Pcb 會簽		XJR: 廖志堅 04/03/23 CHK: 廖志堅 04/03/23 DWG: 劉志航 04/03/23	
Title		GM-03018U/T	
張志華 06/03/23	Size B	Document Number CKT:20010011101 PCB:10230011100 REV:4	Rev A
	Date: Tuesday, March 30, 2004 Sheet 1 of 1

SW: 王德隆 14/03/23		CHK: 廖志坚 3/23/2004		APP: 廖志坚 3/23/2004	
PCB		Title					
		GM-03018U/R					
Size		Document Number				Rev	
B		CKT:20010007101		PCB:10230009100		Rev:9	
3/23/2004		Date:		Friday, March 26, 2004		Sheet 1 of 1

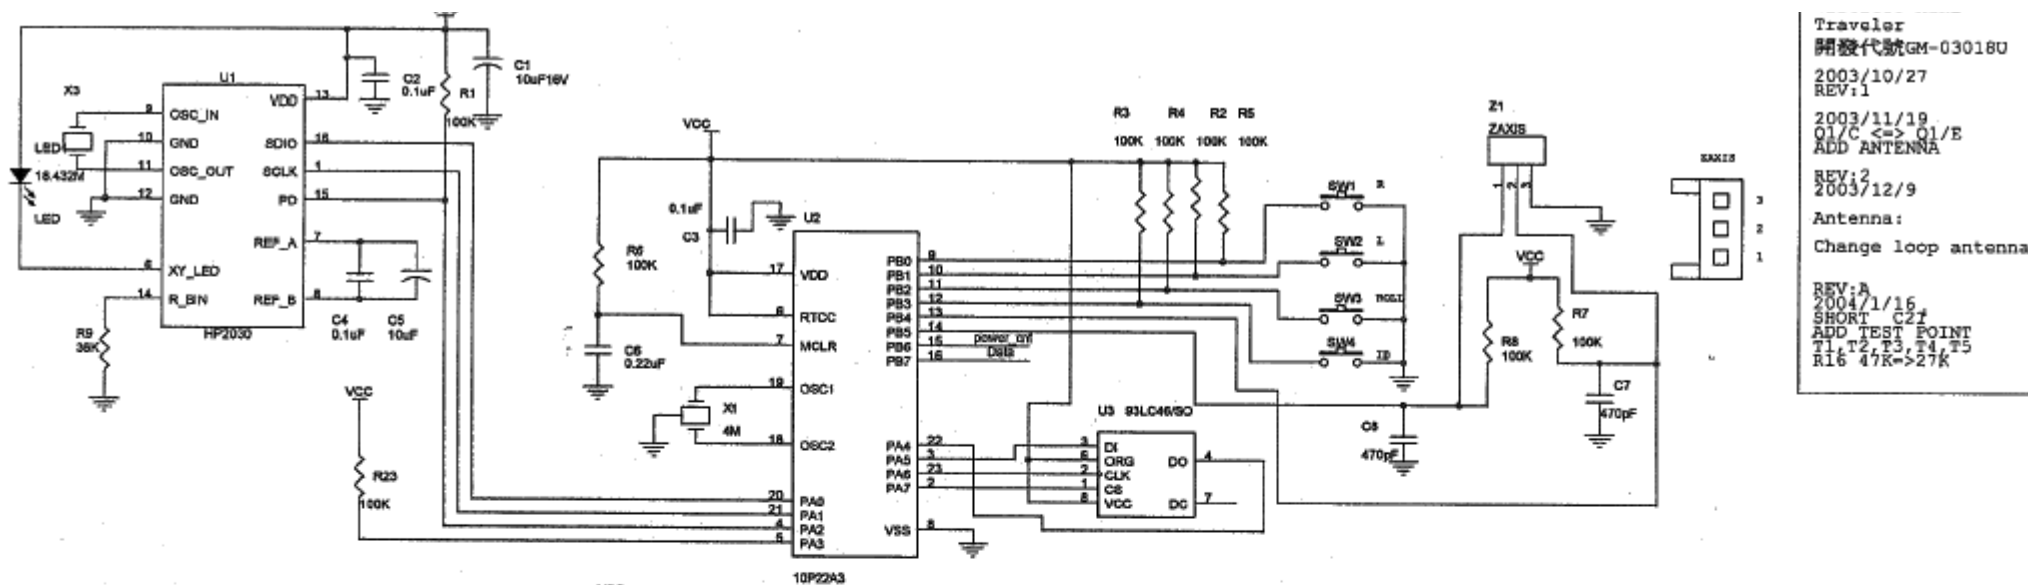
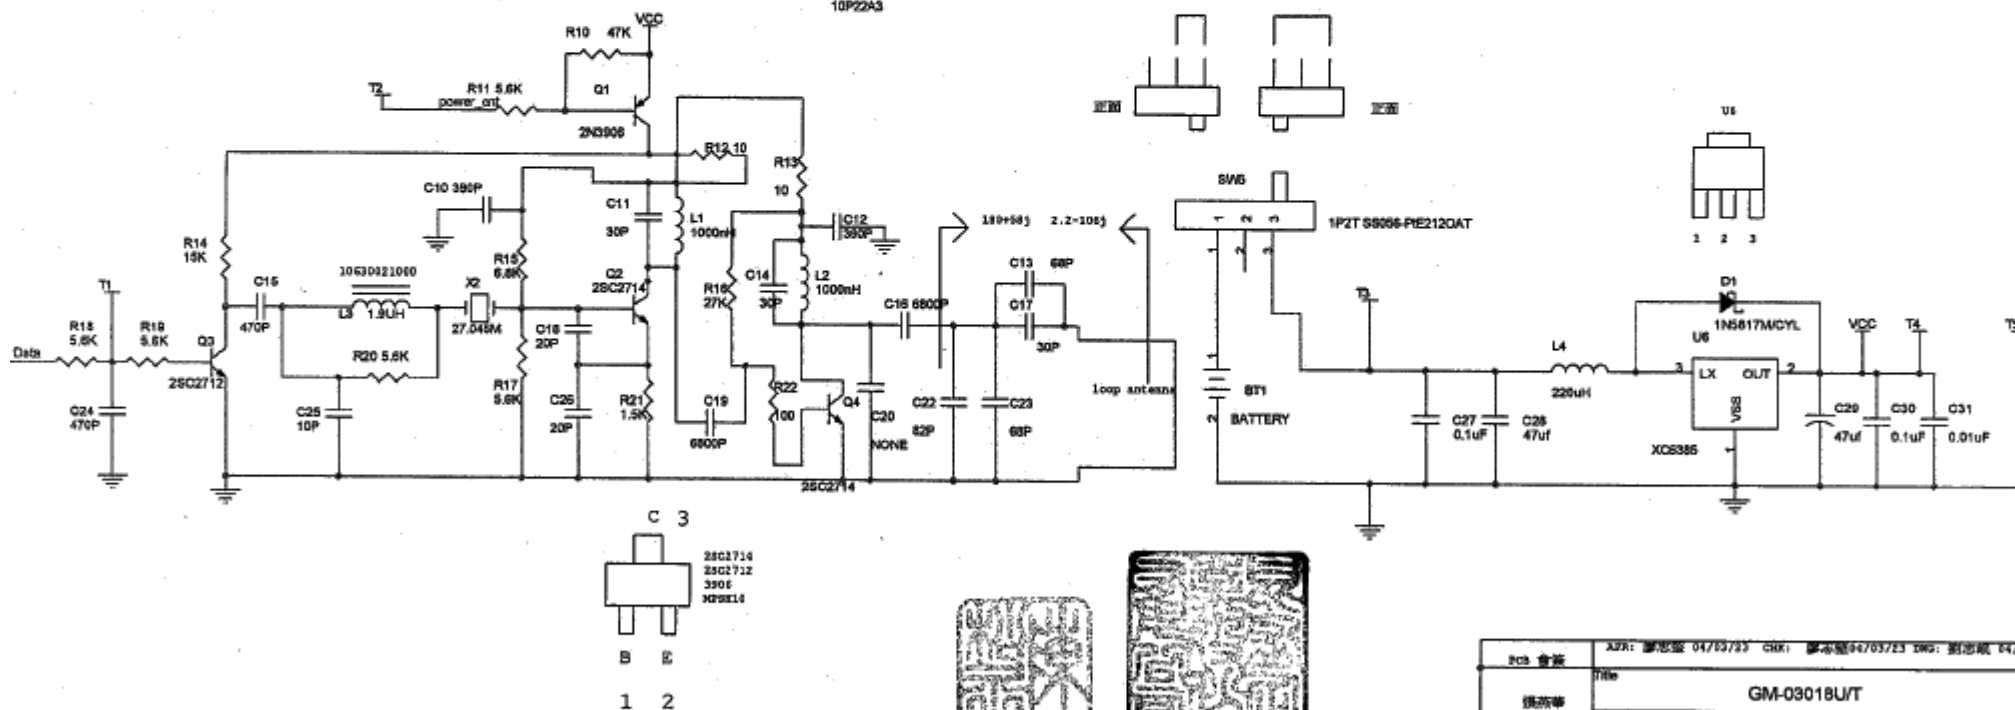
Traveler
開發代號GM-03018U
2003/10/27
REV:1
2003/11/19
Q1/C <=> Q1/E
ADD ANTENNA
REV:2
2003/12/9
Antenna:
Change loop antenna
REV:A
2004/1/16
SHORT C21
ADD TEST POINT
T1, T2, T3, T4, T5
R16 47K->27K

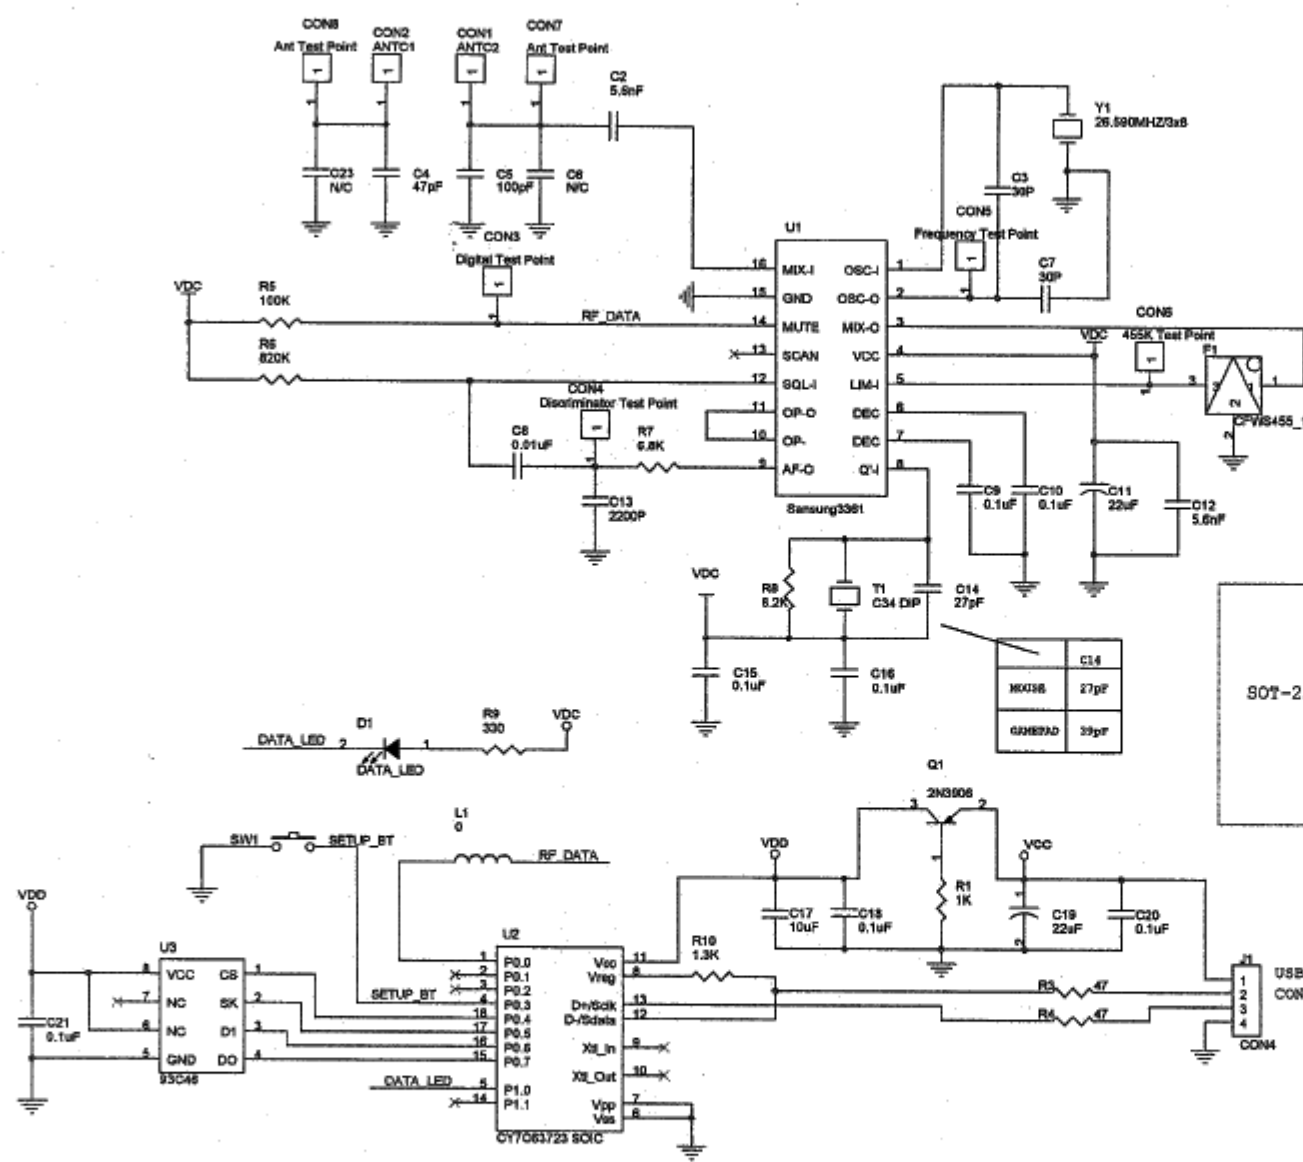
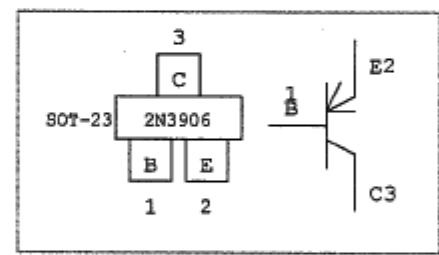
DATE:2003/9/8
Version:1 (New)
DATE:2003/10/7
Version:2
Modify J1 Pin2 Pin4 Change
SW1 For U2 Pin2 to Pin4
D1 For U2 Pin14 to Pin5
Del L2,L3
ADD L3 to VDD
Q1 Relayout
RF POWER USE VDC

DATE:2003/10/20
Version:3
Modify RF IC
For 3261 to
SV1800
DATE:2003/12/18
Version:4
DC:30001564
Add C22 For Ant to GND
Add L4 For C4 to GND
Del C1,C5,C6,L1,R4
L2,L3 Short

DATE:2004/01/16
Version:5
Add C1 Between Q1 and C4
Del C22
改板板

DATE:2004/01/16
Version:6
雙面板

DATE:2004/02/14
Version:7
Del:C1,C4,L2,L3,L4,R1,R2,R3,Q1
Add:C1,C22,L1,Q1,Q2,R1,R2,R3,R4
C11 for Dip to 1210

DATE:2004/03/09
Version:8
DC:30001564
C11 for 1210 to
DIP
